Flat Bush Spatial Structure and Built Form Review 2008

Manukau City Council

transurban[®]
design & planning

6th October 2008

Current subdivision pattern with previous lot boundaries shown dashed

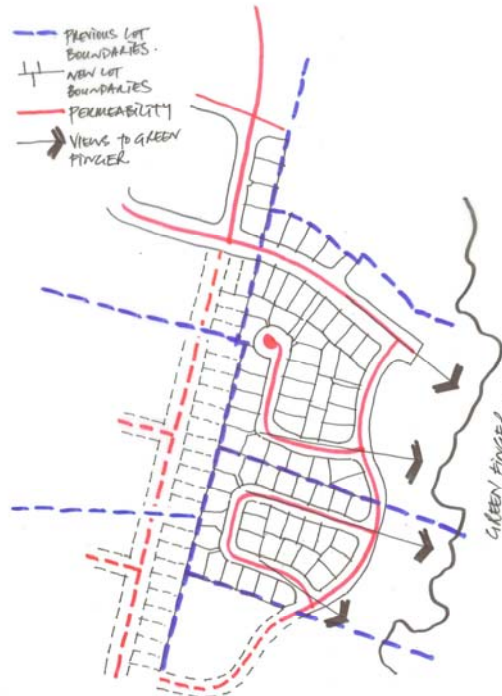
Issue 1 - Subdivision and design has occurred within larger lot boundaries rather than as a holistic design for the area, due to ownership and timing, resulting in poor connections and many rear lots.

Ideas: Provide incentives to develop concept plans for entire blocks or neighbourhoods, not individual lots. Ensure that there are a number of connections to adjacent large lots for future development to be contiguous spatially. Only allow short cul-de-sac streets where the topography (such as very steep land or a cliff) or other constraints (other than ownership issues) require such a street. Provide a more detailed structure plan.

Example of open space within blocks in Flat Bush, assume two car parks per lot

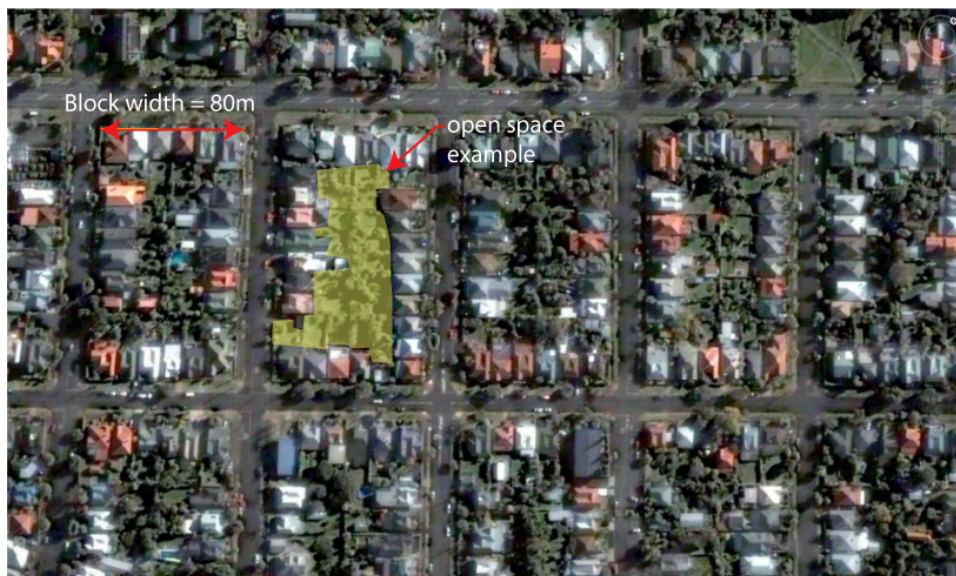
Issue 4 - Width and depth of lots are too similar creating square lots resulting in minimal outdoor space for planting and onsite recreation / amenity.

Ideas: Encourage block designs that facilitate rectangular lots with a back to back relationship that allows useable rear yards or develop courtyard housing suitable for square lots. Establish a Flat Bush Development Team that is a multidisciplinary team with common outcome objectives. This team would advise on all issues relating to Flat Bush. They would review, assess and determine development proposals including subdivisions.

Figure ground illustrating private lane at Flat Bush (left) and photo of the same (above).

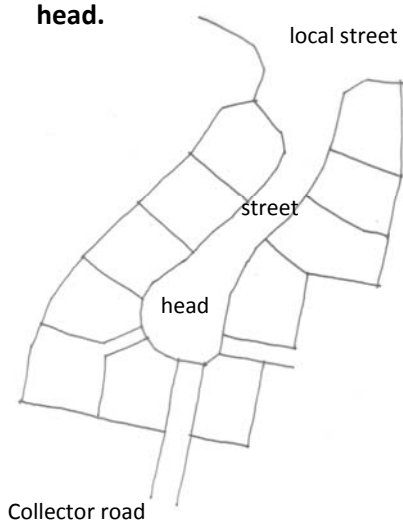
Issue 5 - Rear lots off lanes or ROW don't address the street, reduce the amenity quality of the street and the area, and have privacy and outlook issues with over looking all yards etc.

Rear lots are usually left over space, typically at the end of cul-de-sac streets. The resultant built form on such sites does not address the street or contribute to the spatial form of the street space. Rear lots also significantly reduce the amenity and privacy of adjoining lots where the traditional back to back relationship is confused. Additional street clutter also results with a higher density of vehicle crossings, fences, letterboxes, service pillars, and resulting in generally less trees. The example above goes one step further by creating a private lane to access a number of rear lots.

Ideas: Restrict the development of private lanes with Design Code for Subdivision. Prohibit rear lots.

Existing cul-de-sac in Flat Bush illustrating poor form

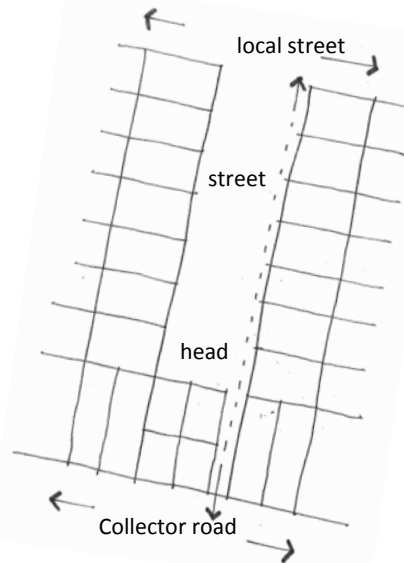
Issue 6 - Hammer head and full turning cul-de-sacs (e.g. Bushpark Place) are not supported by subdivision or building design that strengthens the spatial configuration of the cul-de-sac head.

The subdivision pattern and built form is used to define the spatial configurations of the street. Generally the built form that exists at the cul-de-sac head does little to define the space, and the response is usually a typical setback from the boundary in both the street

Ideas: Provide design principles for designing cul-de-sac streets in design code for subdivision. Subdivision consent must be assessed and approved against the code. Limit use of cul-de-sac streets to locations where the topography or other physical constraints (other than ownership) requires them.

Existing pedestrian and cycle link with no frontage development

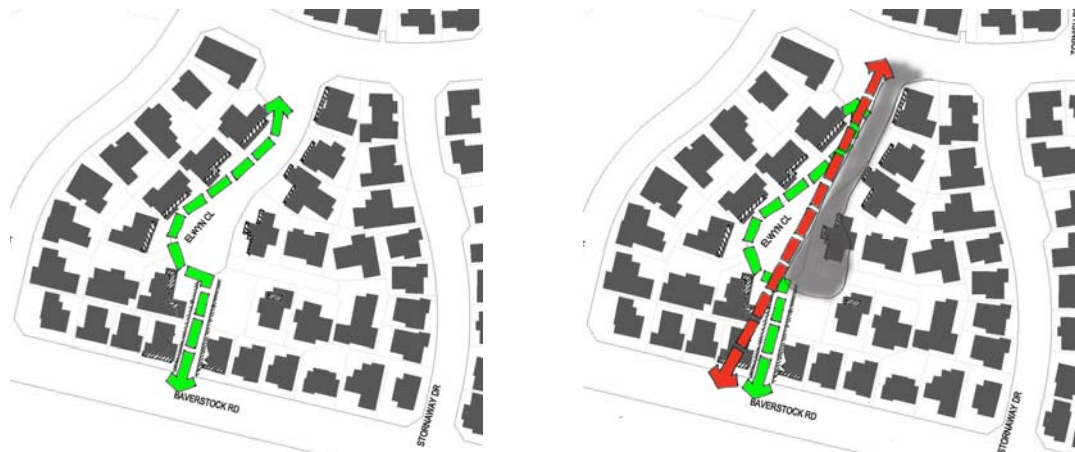
Issue 7 - Cul-de-sac streets are generally short and comply with the standards, but they are not visible for their entire length. Pedestrian connections at the end of cul-de-sacs are not always visible, or overlooked, resulting in an unsafe and undesirable connection or route.

To enhance legibility it is important that cul-de-sacs are visible for their entire length from the intersection with another road. If there is a pedestrian or cycle way connection from the end of a cul-de-sac, it should be visible also to allow people to make decisions on their intended routes and feel safe about using that route. Many unnecessary trips are made down cul-de-sac streets where a person intuitively thinks the street should connect through to another street. The current restriction on lengths of cal-de-sacs appears to be appropriate, however they must be visible for their entire length.

Ideas: Provide design principles within the Design Code for subdivision. Add rule requiring cal-de-sacs to be visible for entire length from intersection with another street.

Upper and lower left illustrates the existing situation at Baverstock School Flat Bush.

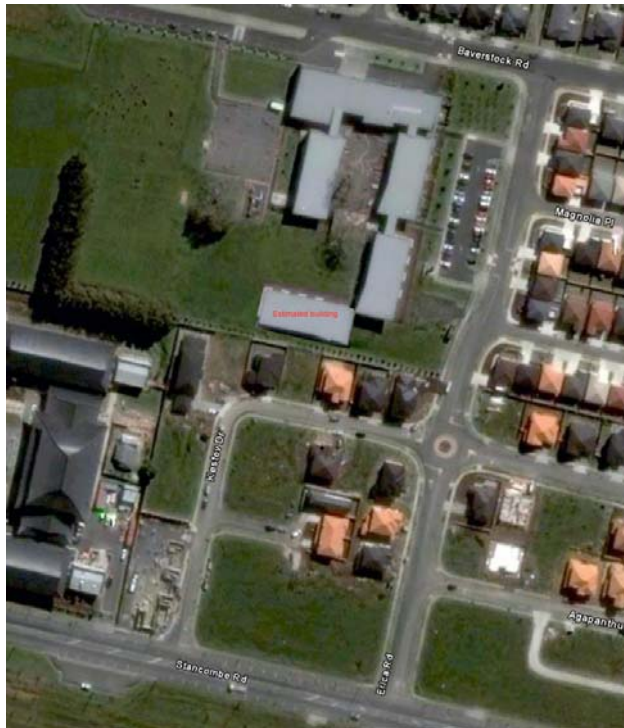
Issue 8 - Subdivisions have created lots that back onto school sites. In one case, the rear yards of lots are overlooked by the school, reducing privacy. There is limited surveillance of the school site from the neighbourhood resulting in safety and security issues. Private lots are less secure and safe due to the rear yards being accessible from the school lot (over a fence). In one case, two parallel fences exist along a boundary which makes the school like a prison.

Schools are an important community facility, although more and more are becoming gated communities themselves. They need to be highly visible by the community to provide the level of safety necessary and reduce the need to secure the perimeter.

Ideas: Consider school sites as open space and that they should be surrounded by streets with residential or other properties fronting these streets overlooking the street and the school. Include principles within the design code and provide a more detailed structure plan.

Existing situation at Baverstock School

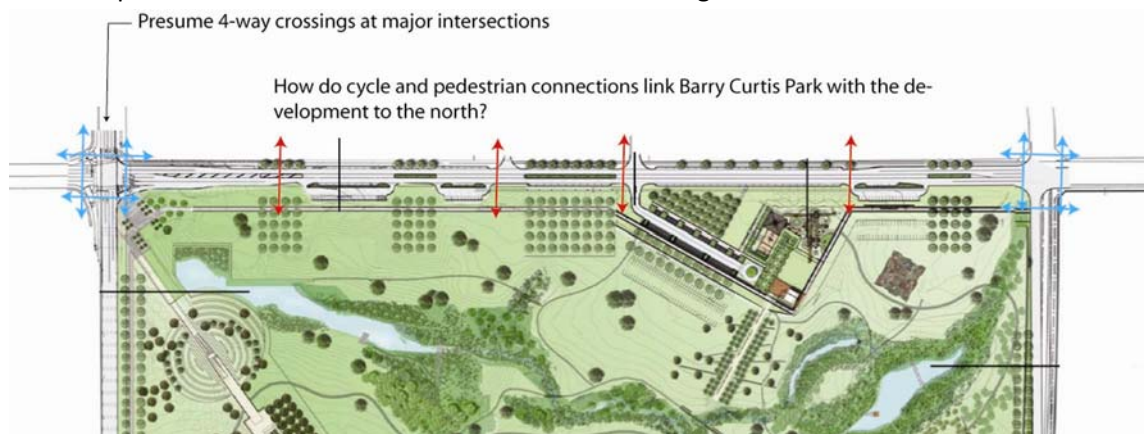
Issue 14 - Limited safety consideration of pedestrians crossing busy main roads.

Ideas: Require all development proposals to design and illustrate how pedestrians, cyclists, disabled people and transport arrive at, circulate through and leave the development. Street design needs to include all elements of the street and the Design Code should provide guidance on principles and a number of alternatives.

Top diagram illustrates the existing situation, the bottom illustrates an alternative

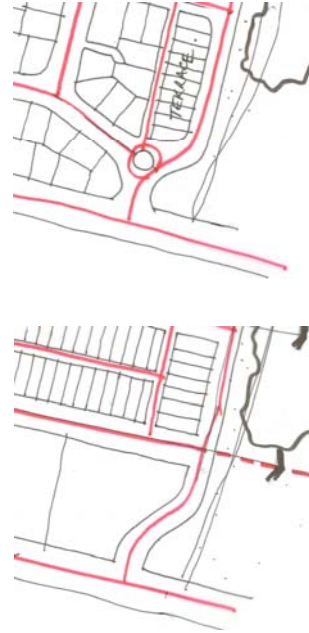
Issue 15 - The alignment and location of streets and lanes significantly impacts the accessibility and permeability of a neighbourhood. The street hierarchy is not always appropriately resolved resulting in lanes having direct access off round-a-bouts at main access points. Local roads must provide access into the neighbourhood, with lanes accessible from these. A lane should not be accessed off a round-a-bout as it confuses the street hierarchy and creates a poor experience.

Example in Area E – Flat Bush

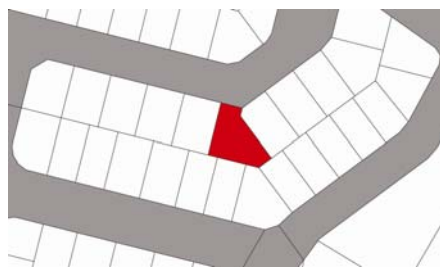
Issue 18 - Front lots that have a very narrow street frontage causing frontage and access issues.

In some cases the lot shape does not facilitate the type of dwelling intended and has qualities similar to a rear lot. The example above illustrates this issue but the design of the site does not help the situation.

The effects of Corner radii on pedestrians (Thomas Telford Publishing (2007), Manual for Streets.)

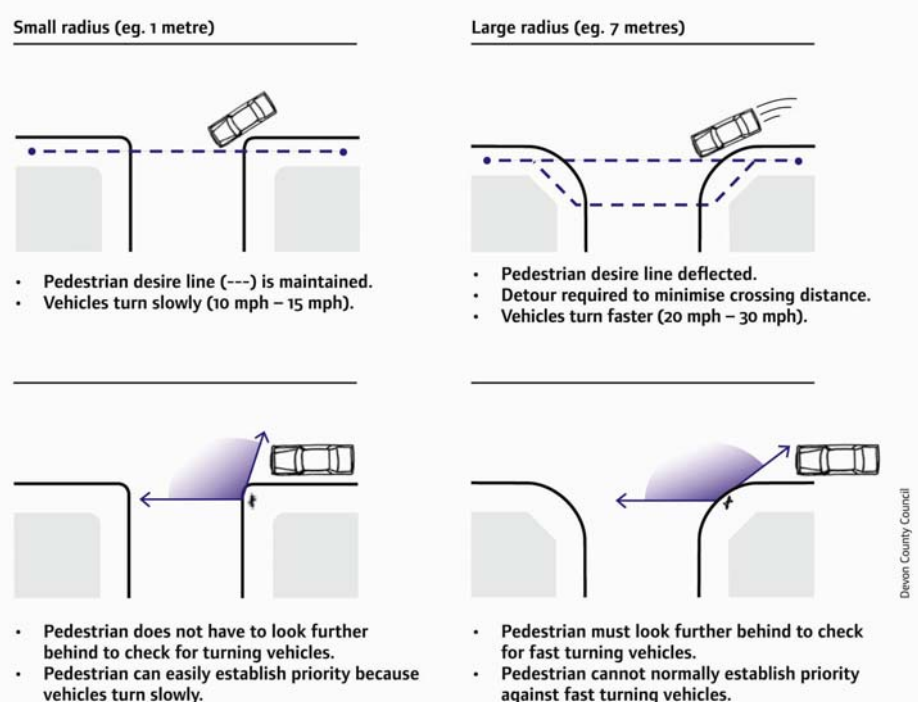
Issue 33 - Large radius corners at street intersections encourage faster vehicle movement and are not ideal for pedestrians. They are a car dominated solution and results in footpath positions and crossings not coinciding with pedestrian desire lines. Design should be specific for the type of street.

Large radius corners can be a result of narrow carriageway widths. It is important that service and emergency vehicles can access all streets but the kerb does not necessarily need to follow the turning circle. It is also important that vehicles do not damage the berms etc.

Ideas: Provide design guidance for intersections at different types of roads to ensure footpaths are aligned and functional for pedestrians in the design code and remove reference to the engineering quality standards. This includes giving pedestrians the best view of vehicles approaching, their path not being blocked by vehicles waiting at intersections etc. Provide a more detailed structure plan.

Existing round-a-bout at Erica Road with alternative simple intersection below

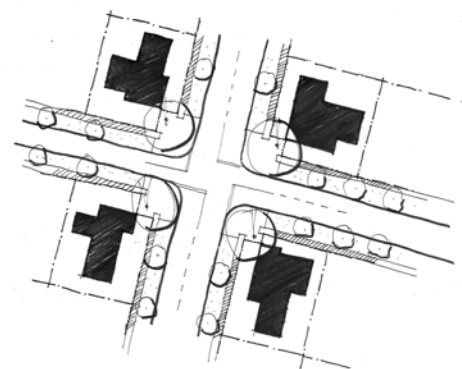
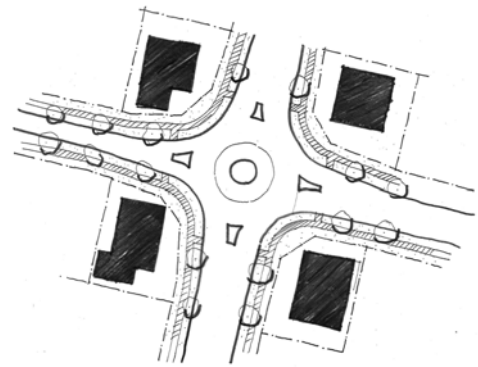
Issue 34 - Round-a-bouts in local streets reduce pedestrian accessibility and amenity due to pram ramps and footpaths not aligned for the desired direction of travel; they take up more land and reduce visibility/views along the street.

Ideas: If the intersection needs to be emphasised or used to slow traffic (or speed up traffic in case of a round-a-bout) then there are other design solutions that can achieve the same effect. Include alternatives in a design code such as creating spatial definition with the use of buildings, or creating intersections for pedestrians to indicate to or warn pedestrians of the potential hazard.

Apartment on Stancombe Road as existing

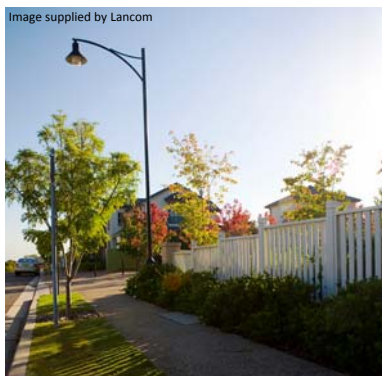
Issue 38 - Lack of transition between the road and residential buildings. No small shrub or ground cover planting occurs in the street berms. This can significantly enhance the quality of the street, especially when buildings abut the street boundary.

Plan of example illustrating the rear terrace not fronting a street for part with no rear yards.

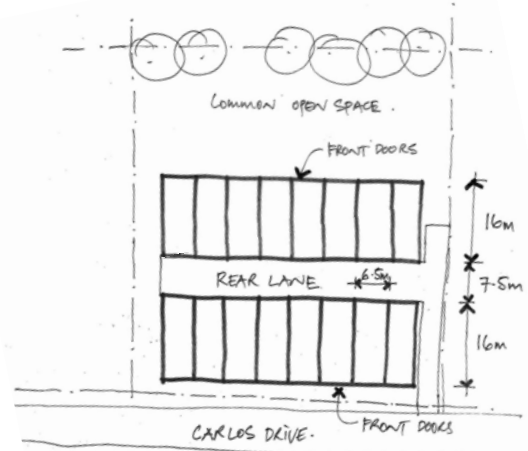
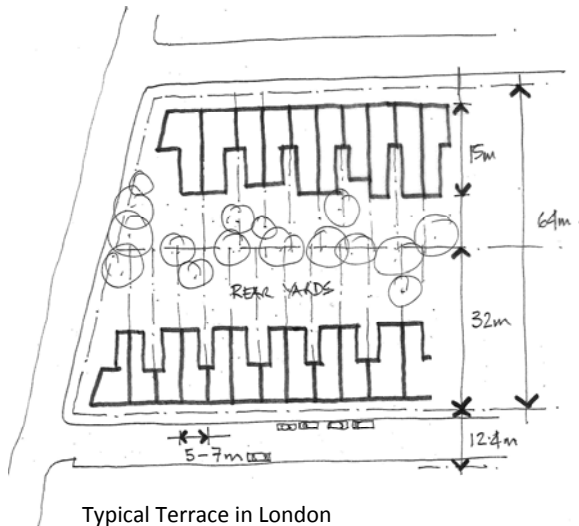
Issue 42 - Mock English Terraces developed not fronting a street as they were originally designed for, and have poor separation and outlook space to the rear due to the vehicle access lane. Design does not understand the typical terrace typology and how it works with the block and street/lane layout.

This example eliminates the rear yard and reduces the size of the dwellings by locating garaging within. There is no privacy to outdoor areas.

Ideas: Require building typology to be appropriately related to the street and the block. Develop blocks within a more detailed structure plan to facilitate the various building typologies.

Diagrams illustrating how important the built form is in defining the spatial structure of a street.

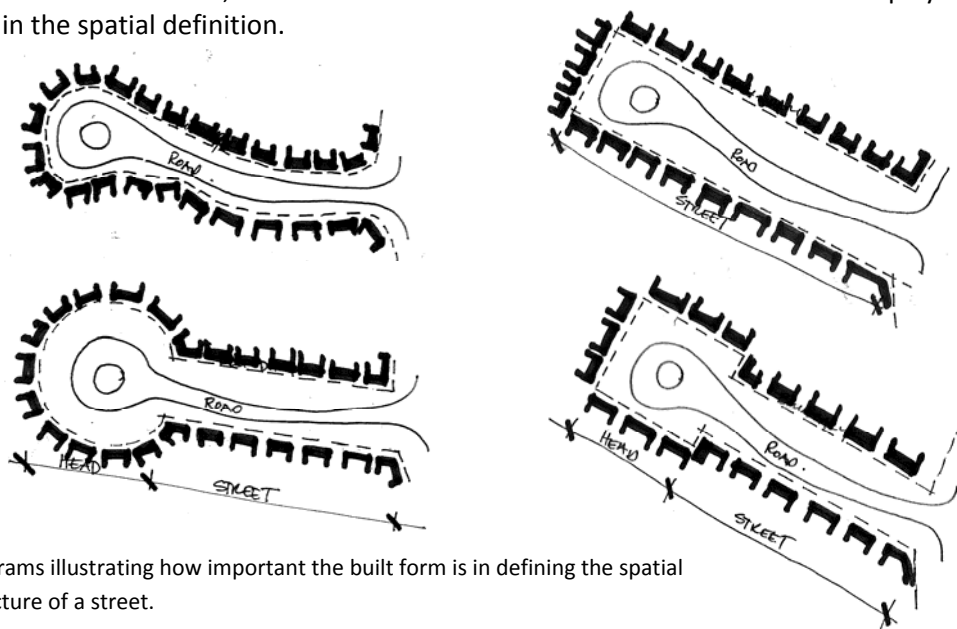
Issue 54 - Spatial definition of the street by buildings is poor. Buildings don't follow the street alignment enhancing its form, nor do the buildings positively address cul-de-sac heads.

This issue is that buildings should define the space, which follows on from that above in the subdivision section, but focuses on the built form and how the built form plays a key role in the spatial definition.

Parks in Flat Bush

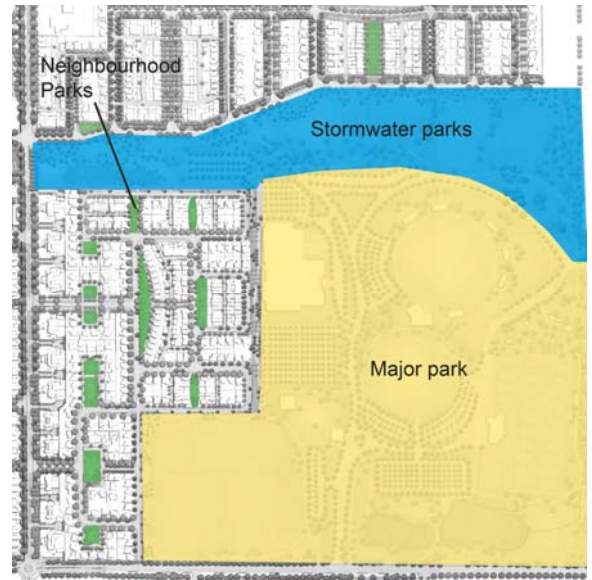
Issue 61 - Lack of small parks such as places to sit, tiny tots play grounds, etc within close proximity of all houses.

Current Bus routes within Flat Bush left. (New routes are proposed)

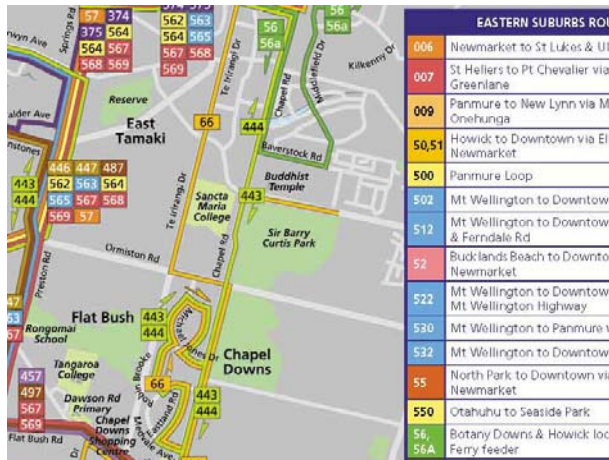
Issue 65 - Bus services are not provided within convenient walking distance of all houses.

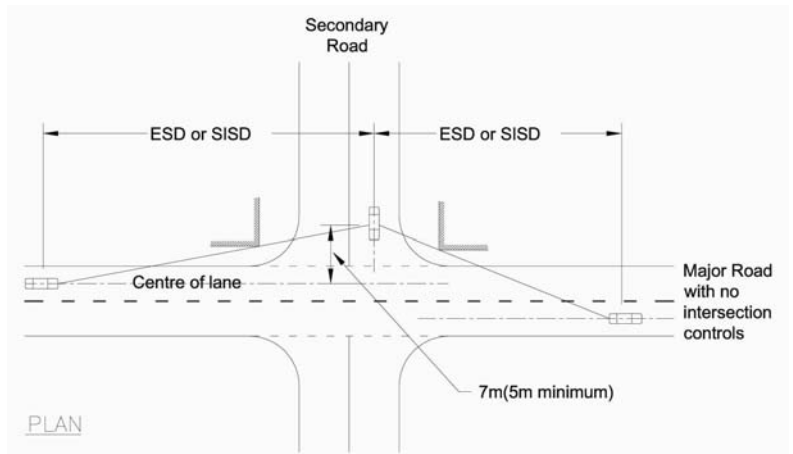
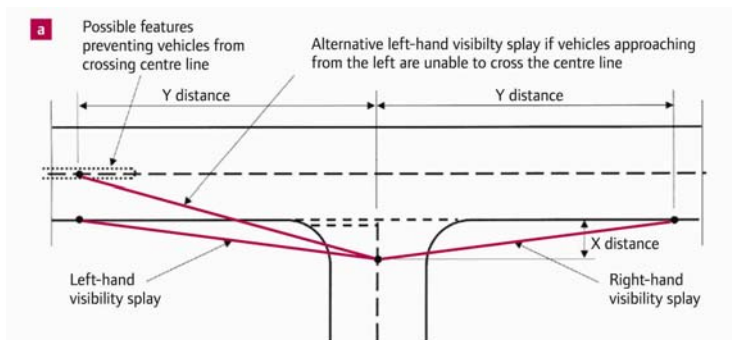
Issue 67 - The engineering standards require a clear sight triangle at intersections which does not necessarily assist with the creation of good streets. It is understandable to have a clear sight line when at the intersection, but not before it.

The current Council standards require intersection design to comply with the diagram to the right. The SISD distance (urban) = 80m at a speed of 50km/h. The position of the driver should be when they are stopped at an intersection.

The Manual for Streets published in England has a slightly different diagram which uses the kerb rather than the centerline of the lane. The following diagram is from Manual for Streets where they recommend that the X distance = 2.4m in most built up situations (front of car to driver's eye, max) and that the Y distance is 45m for speeds of 50km/h.

When comparing the two it would appear that the later has a shorter Y distance, however please note the different positions where the measurements are taken from. For an 8m wide main road and a 4.8m wide secondary road, the Y distance is 4.2m shorter in the later example.
